Option A

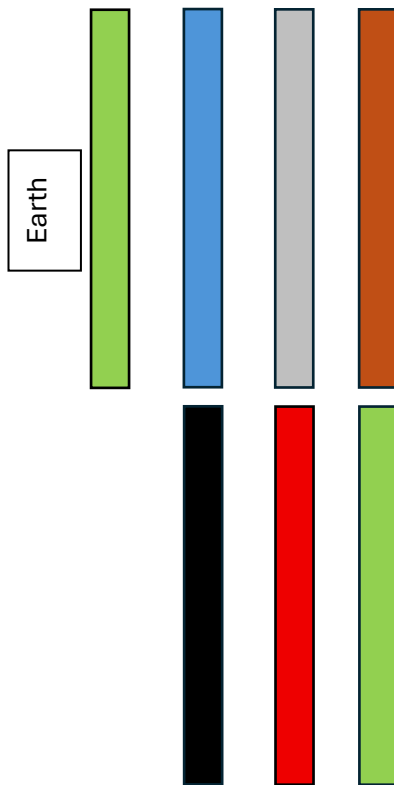
With the unit switched off and isolated from the power supply, swap the following cables from the old-style ball valve to the new ball valve: swap the blue cable with the black cable, the grey cable with the red cable, and the brown cable with the green cable. Disconnect the earth cable, as the new ball valve does not require an earth connection.

Switch the unit back on and check that the ball valve operates correctly. If the ball valve operates in the opposite direction, refer to Option B.

Option B

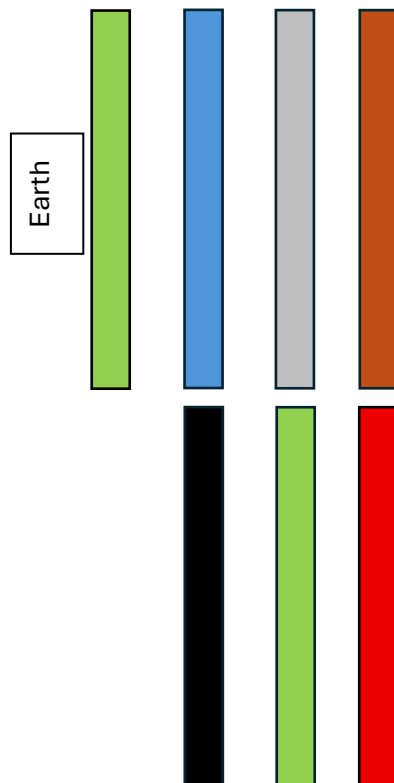
With the unit switched off and isolated from the power supply, swap the blue cable with the black cable, the grey cable with the green cable, and the brown cable with the red cable. Disconnect the earth cable, as the new ball valve does not require an earth connection.

Once all connections are secure, switch the unit back on and check that the ball valve operates correctly.
